Stage 1 Road Safety Audit Report (Feasibility)

**Toddington Lane /Spine Road
Junction, Littlehampton
S278 Highway works**

**Produced for:
Persimmon Homes**

Date: 12th January 2022

13. Identified Road Safety Audit Matters location plan

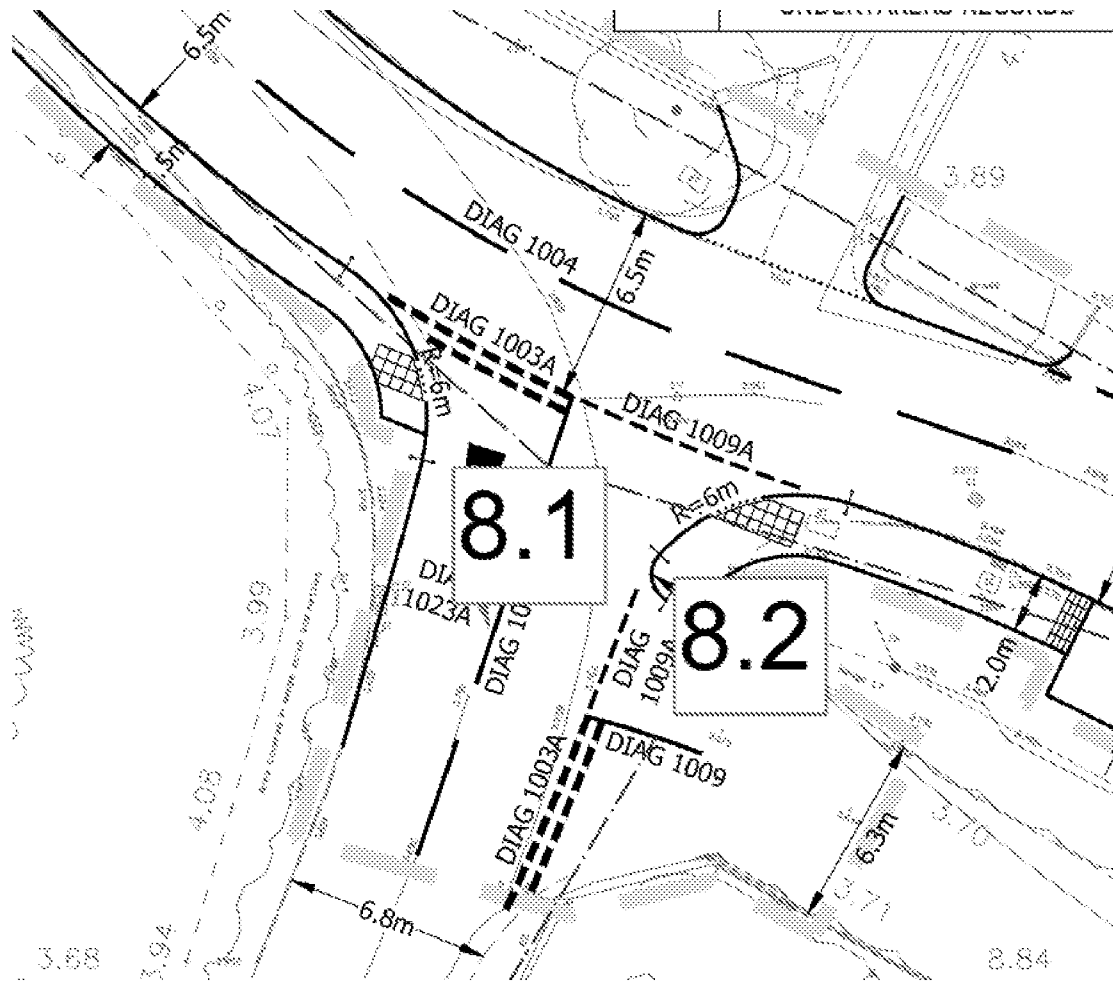
8.1 *Problem* (Item A3.1)	
Location:	Access to Tulley Cottages
Summary:	Access located close to junction give way resulting in insufficient space from right turn vehicles to wait before give way line
There is a vehicle access to Tulley Cottages that appears too close to Toddington Lane give way. Right turning vehicles out of the access appear to have insufficient space to turn out and wait without blocking back across the south bound lane. Carry out vehicle swept path analysis to show right turn vehicles can turn out of access and wait without blocking across southbound traffic lane	
TYPE OF CONFLICT/COLLISION	
Vehicles blocking Toddington Lane south bound lane resulting in collisions	
RECOMMENDATION	
Carry out vehicle swept path analysis to ensure access can be used safely without blocking south bound lane

8.2 *Problem* (Item A3.2)	
Location:	Toddington Lane /Tulley Cottages access
Summary:	Reduced visibility to right of oncoming left turn vehicles from spine road at access
There is reduced visibility to the right of left turning vehicles from the spine road for vehicles exiting Tulley Cottages access. Ensure adequate visibility is provided at access	
TYPE OF CONFLICT/COLLISION	
Collisions due to reduced visibility at access	
RECOMMENDATION	
Ensure adequate visibility is provided at access

Item	Problem	Recommendation	Designer's Response	Overseeing Organisation Response	Agreed RSA Action
8.1	Location: Access to Tulley Cottages Summary: Access located close to junction give way resulting in insufficient space from right turn vehicles to wait before give way line. Type of Conflict/Collision: Vehicles blocking Toddington Lane south bound lane resulting in collisions.	Carry out vehicle swept path analysis to ensure access can be used safely without blocking south bound lane.	Accepted. A vehicles swept path analysis has been carried out for a large car exiting Tulley Cottages turning right and waiting behind another large car. The tracking shows the rear of a car waiting behind another car encroaches slightly onto the other lane. However, there is still sufficient room for vehicles travelling south bound.

Item	Problem	Recommendation	Designer's Response	Overseeing Organisation Response	Agreed RSA Action
8.2	Location: Toddington Lane / Tulley Cottages access Summary: There is reduced visibility to the right of left turning vehicles from the spine road for vehicles exiting Tulley Cottages access. Ensure adequate visibility is provided at access. Type of Conflict/Collision: Collisions due to reduced visibility.	Ensure adequate visibility is provided.	Accepted. A visibility splay to the right of vehicles existing Tulley Cottages has been shown on the revised drawings. Please note this visibility is fundamentally unchanged in the revised junction. Visiblty to the right is restricted by the presence of a hedge between Tulley Cottages and the Spine Road. There is a sign post within the visibility splay, which, however, doesn't reduce visibility significantly.
